Re: **#13ITB87610K-JD–Carnes Wall Panel Cladding Repair and Roof Replacement**

**#13ITB87610K-JD – Carnes Wall Panel Cladding Repair and Roof Replacement
Addendum No. 3
Page Two**

This Addendum forms a part of the contract documents and **modifies** the original ITB documents as noted below:

1 METAL PENTHOUSE CURB DETAIL
 SK2 1 1/2" = 1'-0"

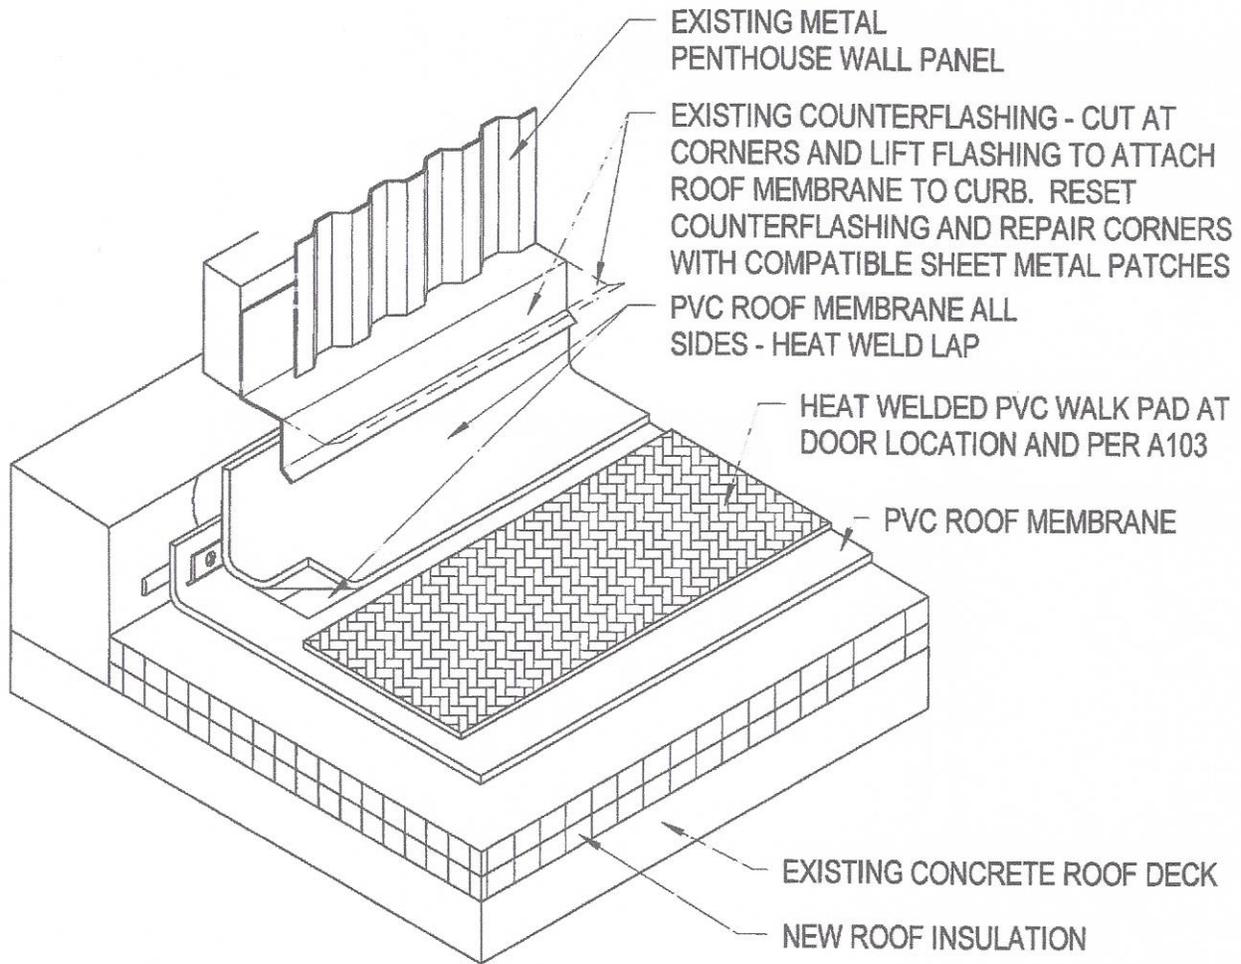
7. Is the Penthouse Roof to be repaired or replaced? Detail 7/A503 shows new PVC Roof Membrane at the Penthouse Roof.

THIS DETAIL TO REPLACE DETAIL 7/A503
 ON DRAWINGS DATED 02/26/2013

RESPONSE: See Drawing SK-2 ATTACHED
